MANDATORY SERVICE BULLETIN MSB D4-097/3

SUPERSEDES MSB D4-097/2

Installation of a start assist relay for ECU start phase monitoring.

WI-MSB D4-097

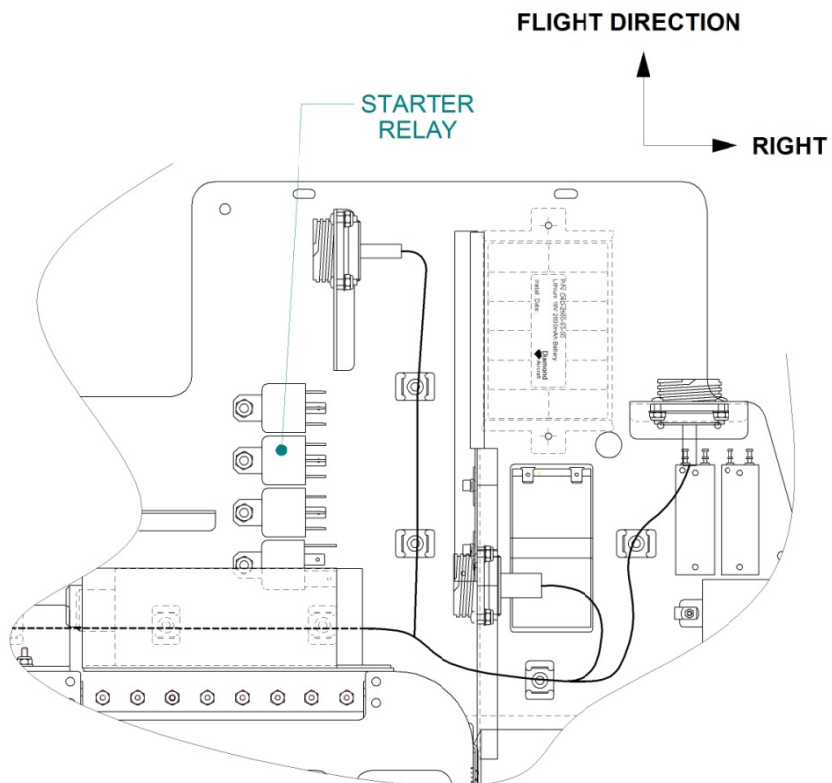
1	Disconnect the main battery for maintenance i.a.w. AMM Section 24-34.
2	Remove the instrument panel cover i.a.w. AMM Section 25-10.
3	Remove wire 24321A22WH from the ECU Test button using a soldering iron.
4	Move the seal of the splice over wire 24321A22WH and crimp it to the wire of the Starter Info Board (P/N 40-8010-E000601) labelled "3" using Splice, red P/N D-436-36. Shrink the seal using an appropriate heatgun.
5	Move the heatshrink P/N FT500-240 over the wire labelled "4" of the Starter Info Board and solder the wire to the terminal of the ECU Test button where wire 24321A22WH was previously installed.

Conventional Instrumentation:

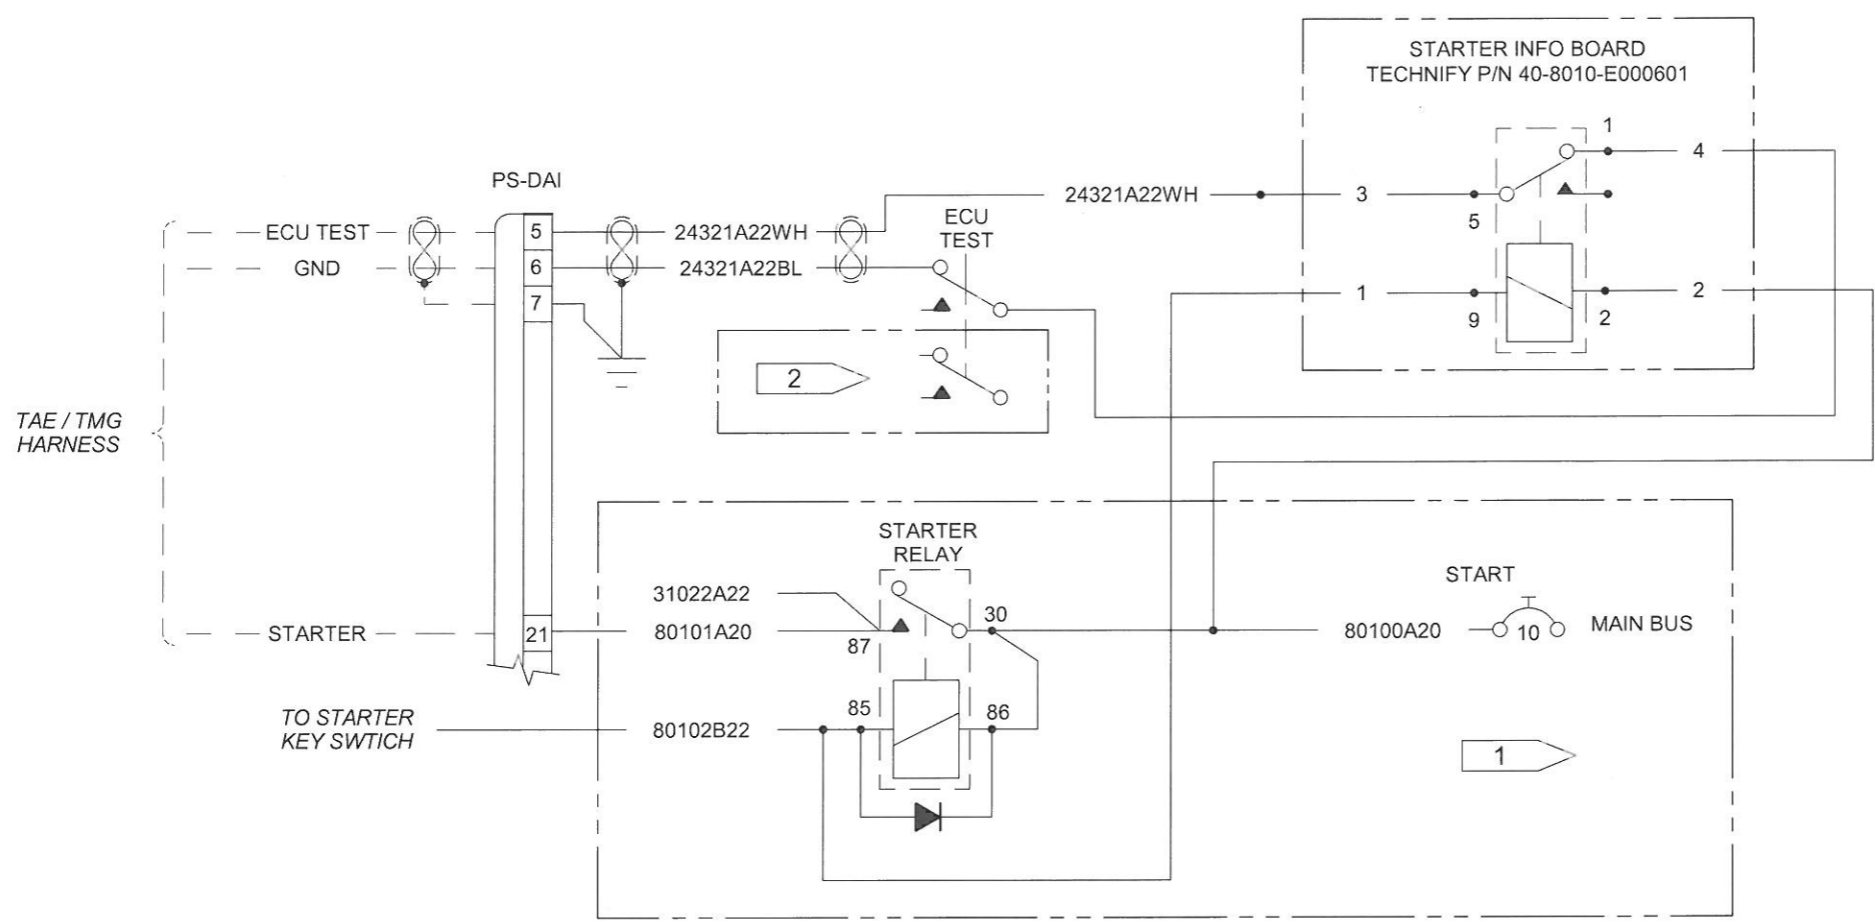
6 Locate the starter relay in the instrument panel.

7	Cut the wires labelled "1" and "2" of the Starter Info Board to appropriate length and splice the wires to the wires 80102B22 and 80100A20 respectively using Splices P/N D-436-37. Refer also to wiring schematic D4D-9224-30-06.
8	Secure the Starter Info Board and all other wires to the instrument panel harness using cable ties.
9	Clean working areas, check for foreign objects.
10	Install the instrument panel cover i.a.w. AMM Section 25-10.
11	Connect the main battery after maintenance i.a.w. AMM Section 24-34.
12	Install ECU firmware and mapping in accordance with MSB D4-044/15 or later effective issue.
13	Check all altered, replaced, repaired parts for proper function.
14	Test all systems in working area for function.
15	Make all necessary entries in the airplane and engine logs.
